1CAN030101

Subject: Arkansas Nuclear One - Unit 1
Docket No. 50-313
License No. DPR-51
Response To NRC Requests For Additional Information On ANO-1 Steam Generator ODIGA

**ANO-1 Requests for Additional Information to the ODIGA Amendment Request
Dated August 29, 2000**

Figure 25
POD for ODIGA

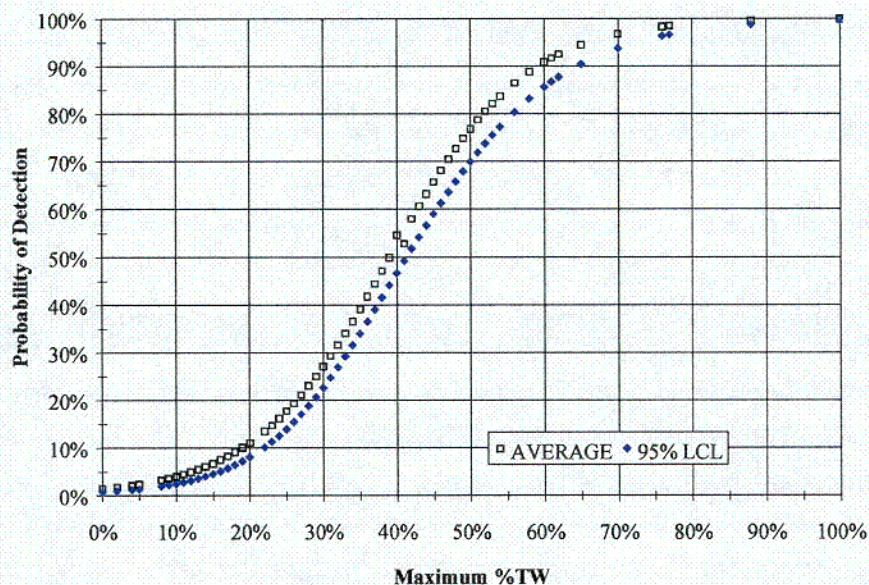
In the 8/29/00 Entergy submittal, 1CAN080005, a probability of detection (POD) curve for ODIGA is provided as Figure 25 on page 56. It appears that this is the same POD curve presented in the Entergy 9/7/99 submittal, 1CAN099901 (BAW-10235P, Rev. 1). The 9/7/99 report states that the POD is based solely on ODIGA defects in tubes removed from various once-through steam generator (OTSG) plants. How does the POD for

ODIGA detected at ANO-1 compare with that from the other OTSG plants represented in this analysis?

The POD curve submitted came from BWOOG Report 77-1258722-00, Probability of Detection of Defects in Once-Through Steam Generators (Dec. 1997). The original POD curve contained pulled tube data from Crystal River, Oconee, and a small number of older samples from ANO-1 and Rancho Seco. In 1998 three pulled tubes from ANO-1, four from Oconee 3 and two from TMI were added to the database. The attached POD graph shows very little change from the 1997 data to 1998 data.
